# Technical Bulletin

## Volume Controls PJ 74/77/78 Improved Plating

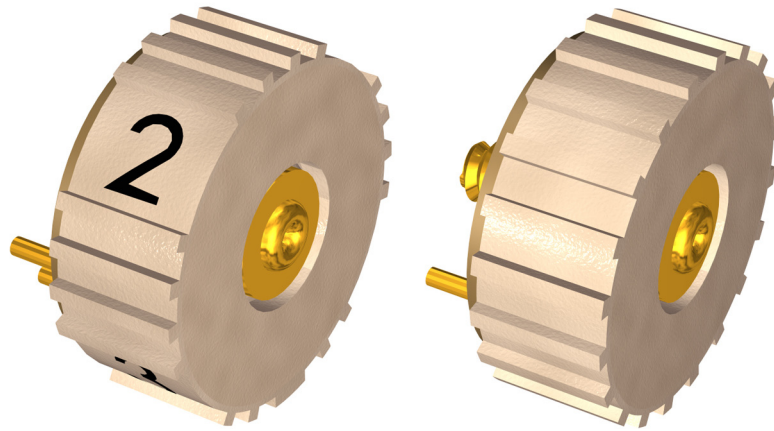
**S**onion is pleased to announce that we have improved the plating of the above mentioned product groups.

The gold-flash plating of 0.5  $\mu\text{m}$ , which replaces the current passivation of the silver terminals, results in the following improvements:

- Extended storage time
- Improved solderability

The change will not affect part numbers and will be implemented gradually during 2003. Due to the difference in current inventory levels, you may receive volume controls with mixed gold-plated and passivated silver parts in the transition period.
